CHABOT-LAS POSITAS COMMUNITY COLLEGE DISTRICT PURCHASING DEPARTMENT

Addendum No. 2

REQUEST FOR PROPOSAL BID: B23/24-05 Pool Resurfacing Project at Las Positas College

DP-4

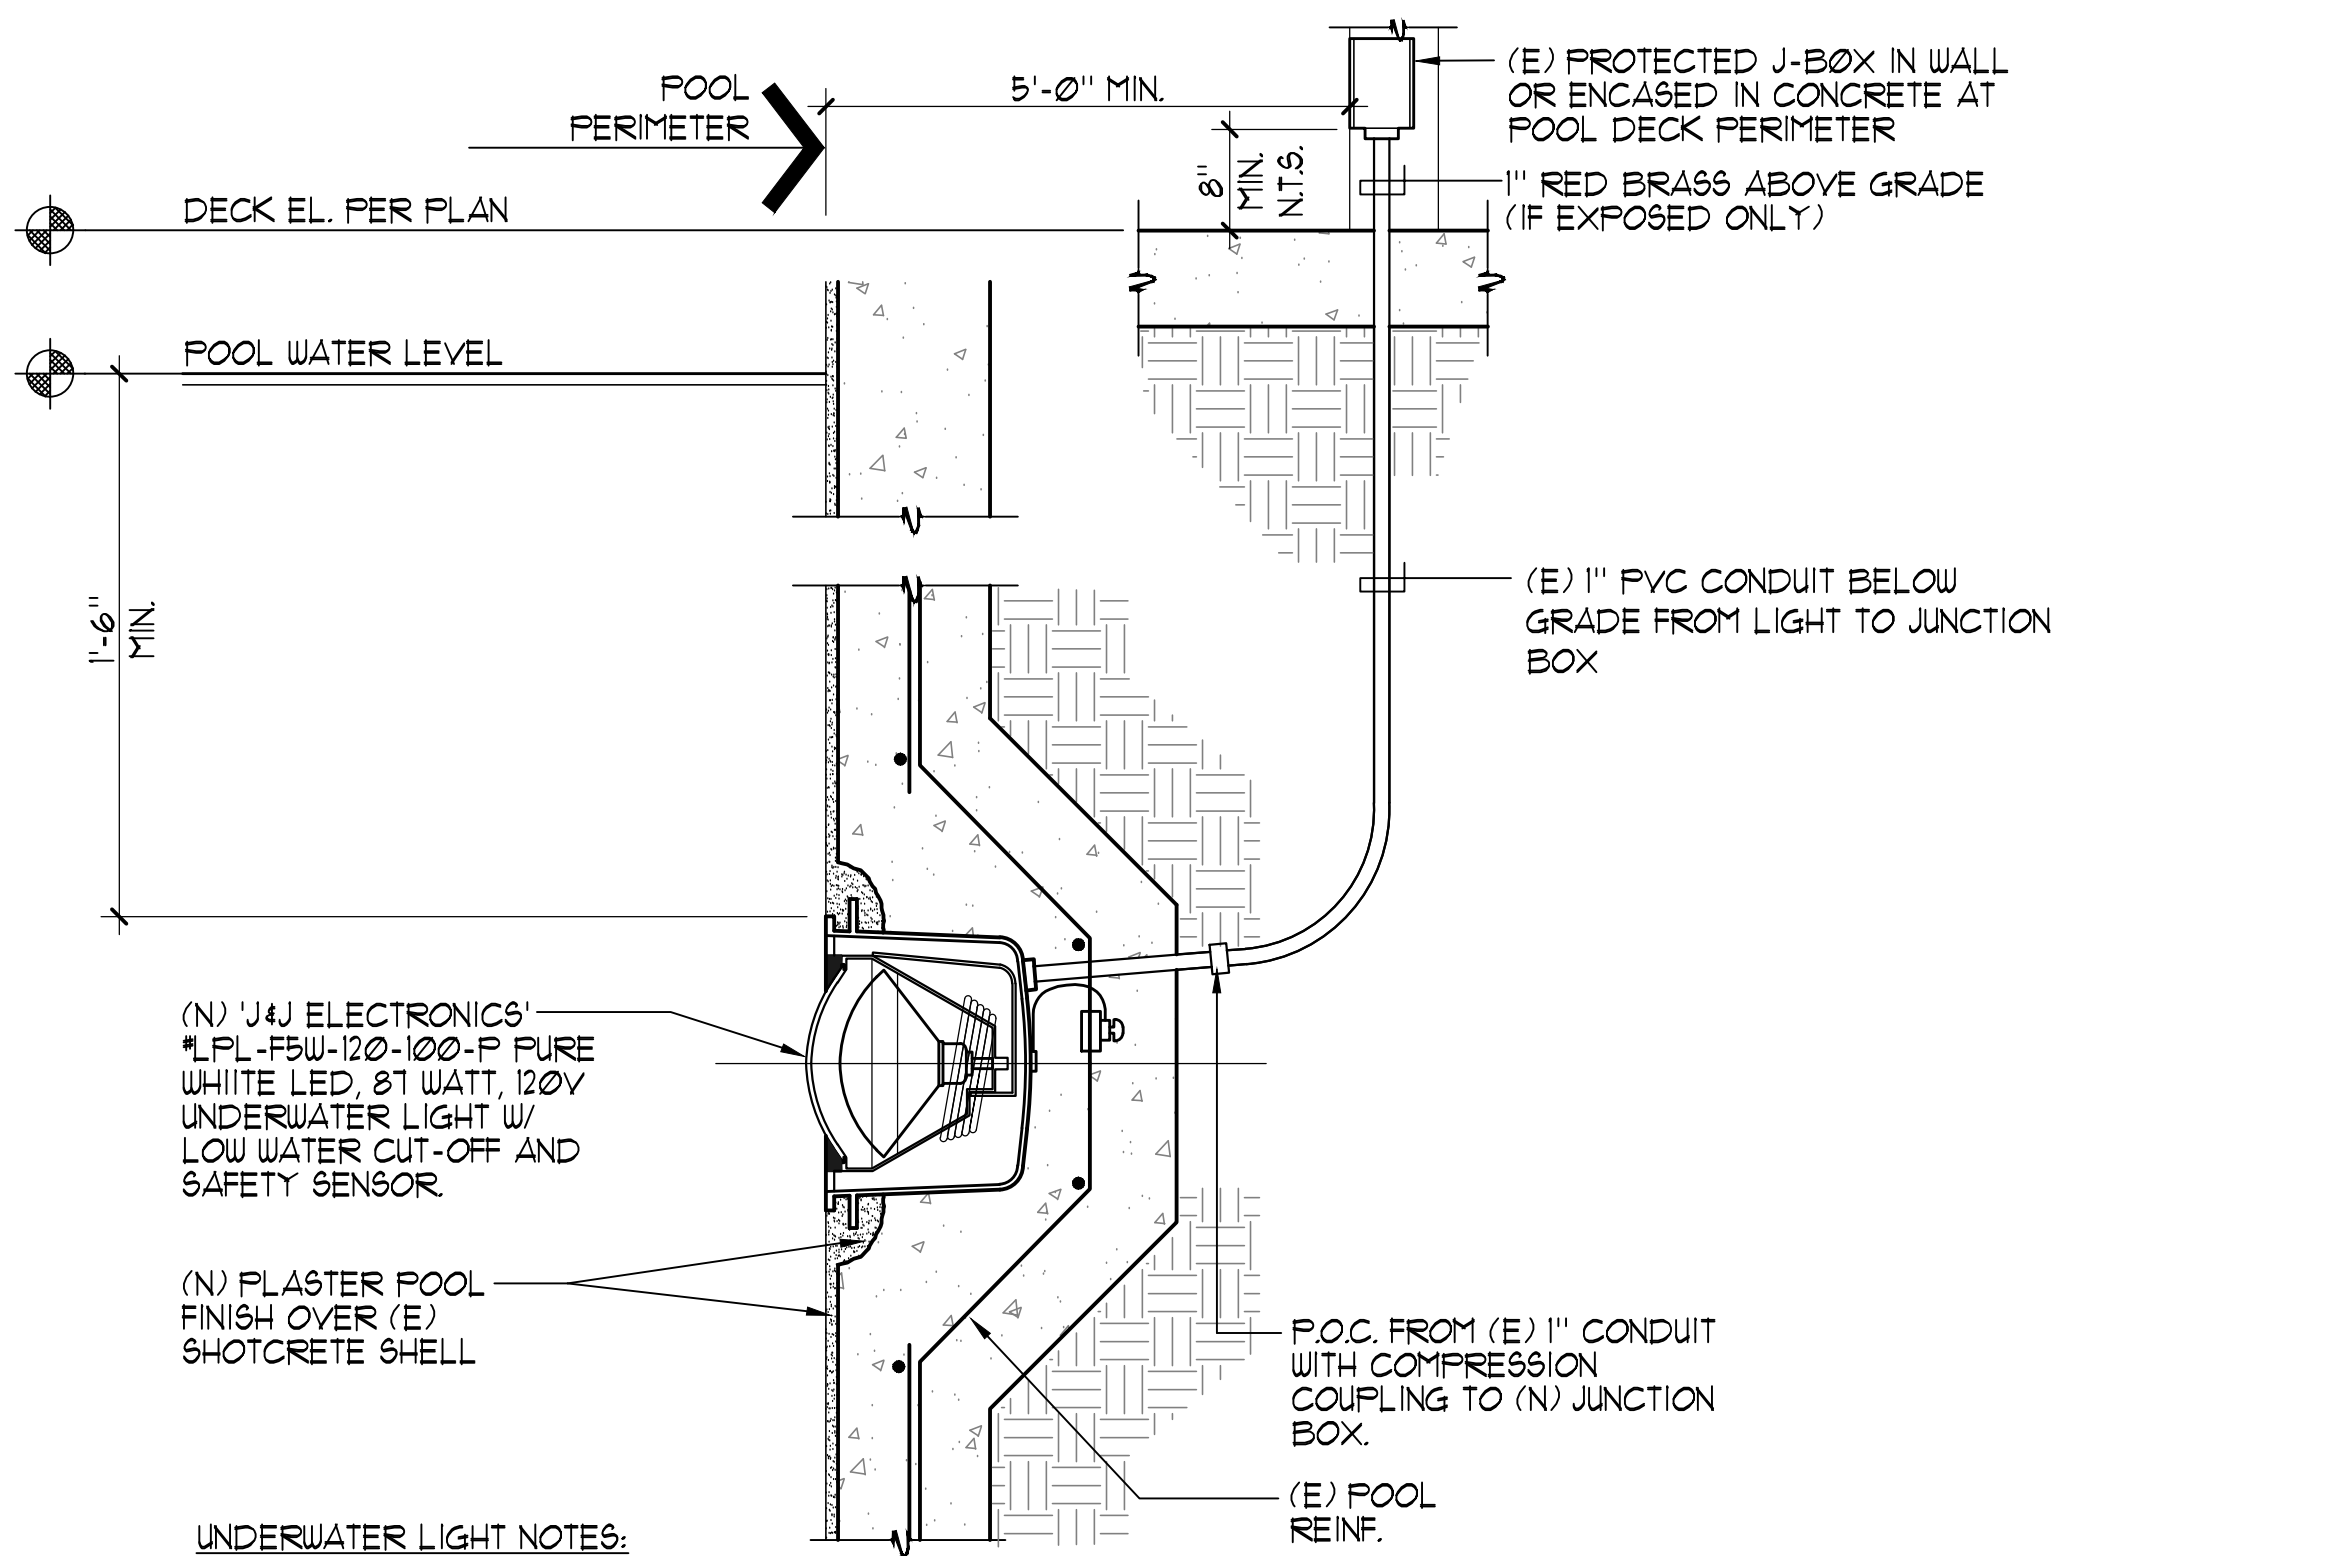
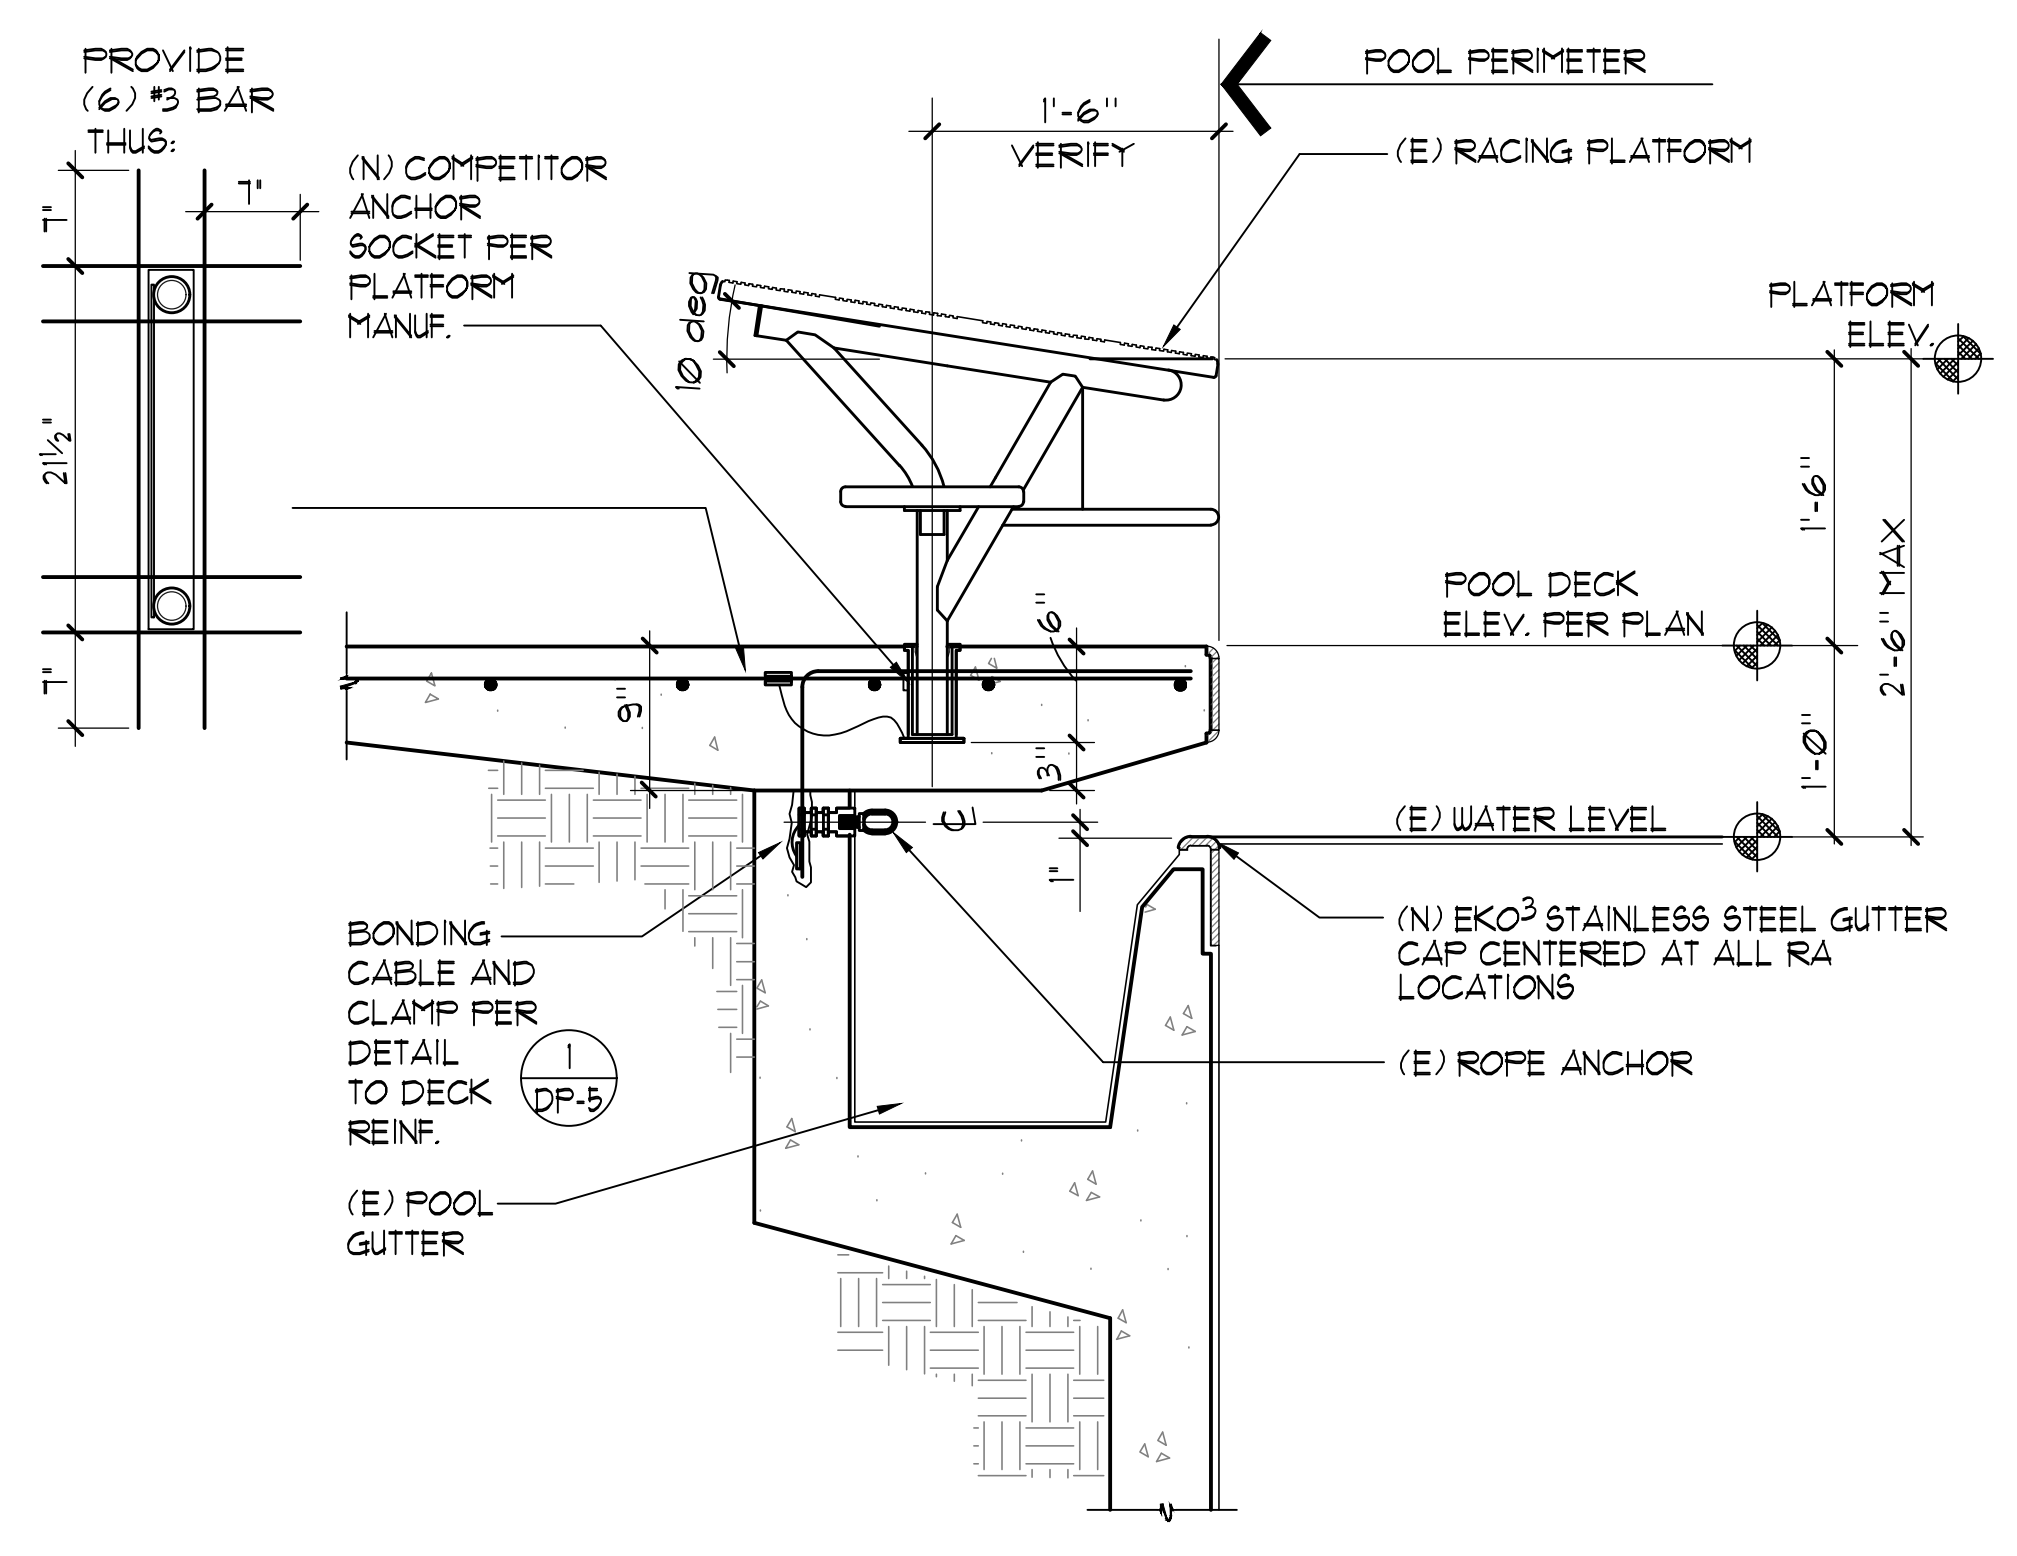
5. **Sheet DP-4 Details:** See note #2 for clarification regarding conductors to pool. See note # 7 for clarification regarding new underwater lights.
6. **Sheet DP-5 Details:** Coordination with sheet DP-2.2. See revised 3 and Detail 5 with revised notes to indicate all new Dive Boards and Stands to be installed.

Question No. 9: Sheet DP-4 detail #4 shows work to be performed to an existing Expansion Joint detail. Do either of the existing pools have an existing expansion joint matching this detail?

Response: ADG Response: We are not aware of any expansion joints in either pool. This detail is shown in case an unexpected one is encountered.

4 (N) CONCRETE DECK JOINT DETAILS 1/2" = 1'-0"

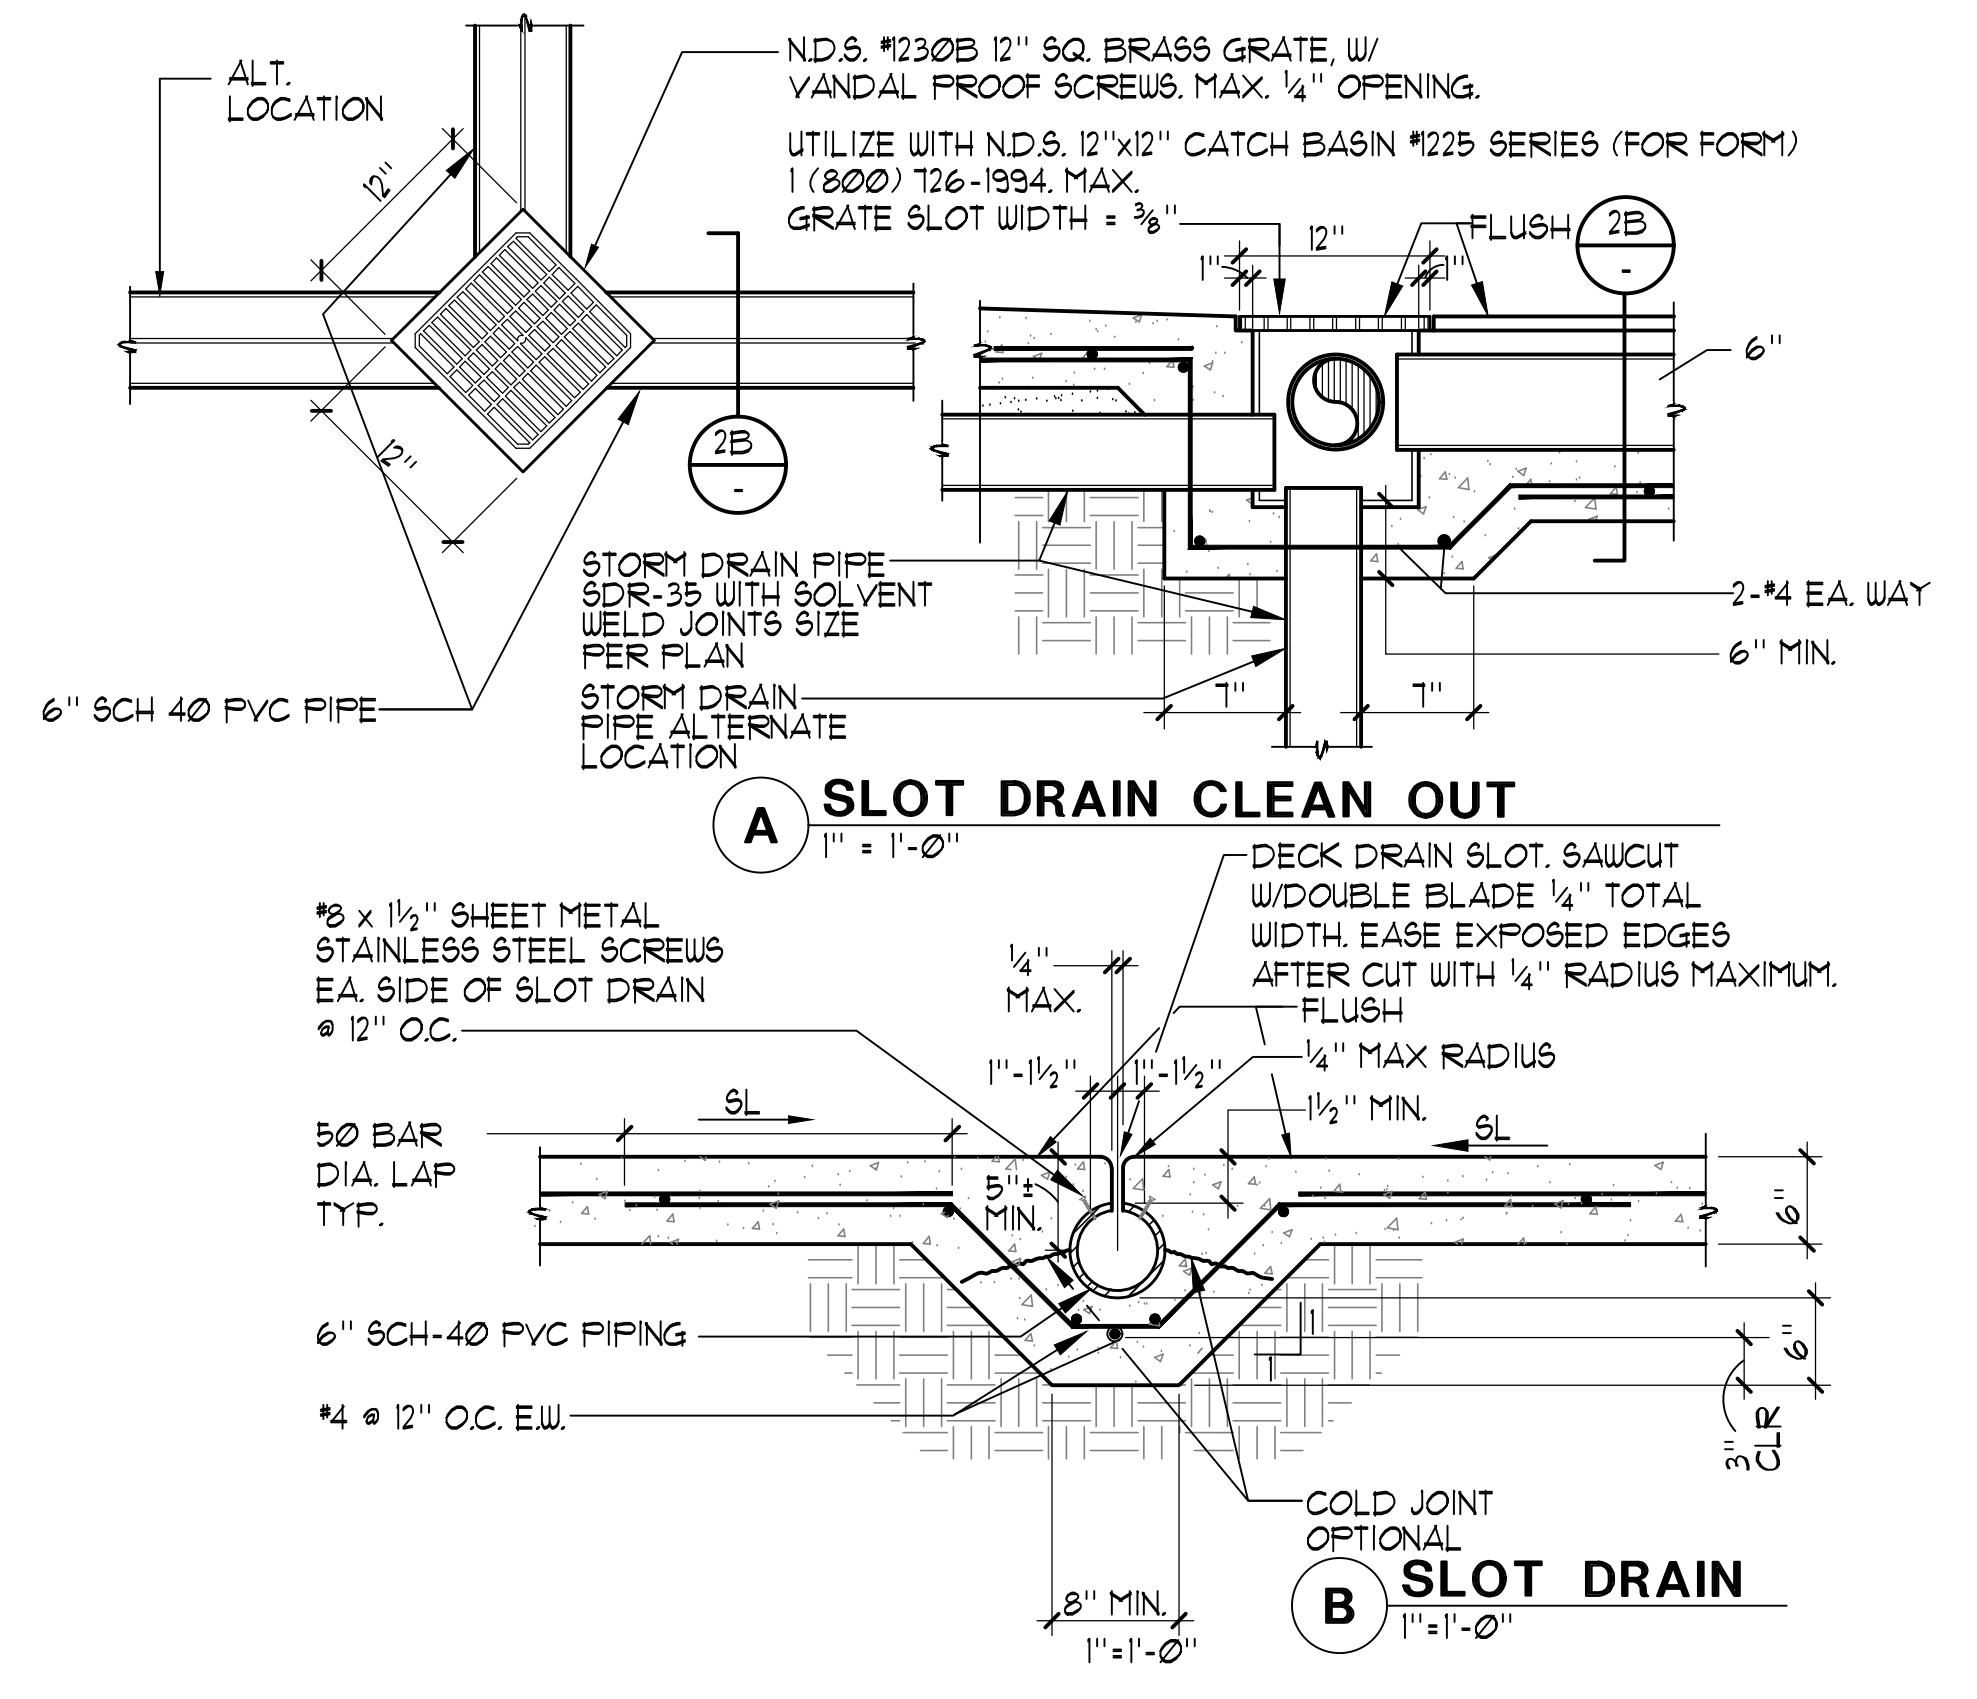
7. **Sheet DP-7 Details:** Reference detail #4 for Deck Joint Details and RFI response #14.
8. **Sheet DP-9 Details:** Clarifications provided on note #1
